Access Compliance Report

Public Rights-of-Way

(Curb Ramps)

Intersection ID: 29145	Main Street: CRAWFORD_BROOK_LN	Cross Street: DEATON_HILL_DR	Location: NW
ADA ID: 8721D9680B7D	Ramp Type: BlendTrans1	Initial Pass/Fail: Fail	Overall Compliance: No
			Severity Score: 21.25

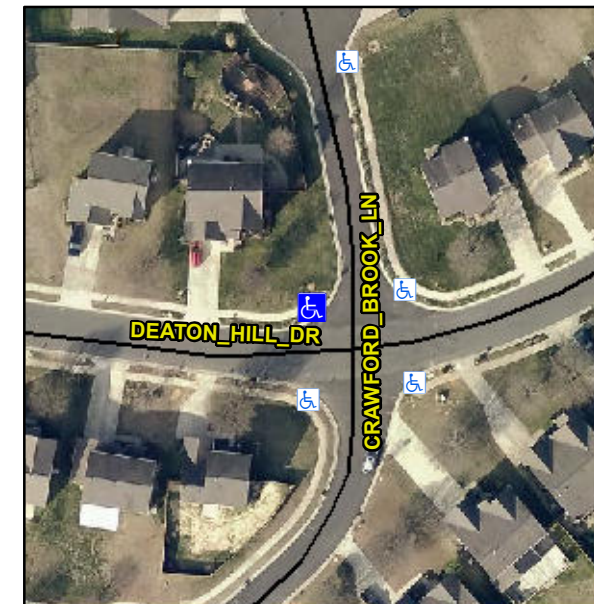
Not Found, R304.5.1, R304.5.3

Remove & Replace Curb Ramp With Two New Directional Ramps or Equivalent.
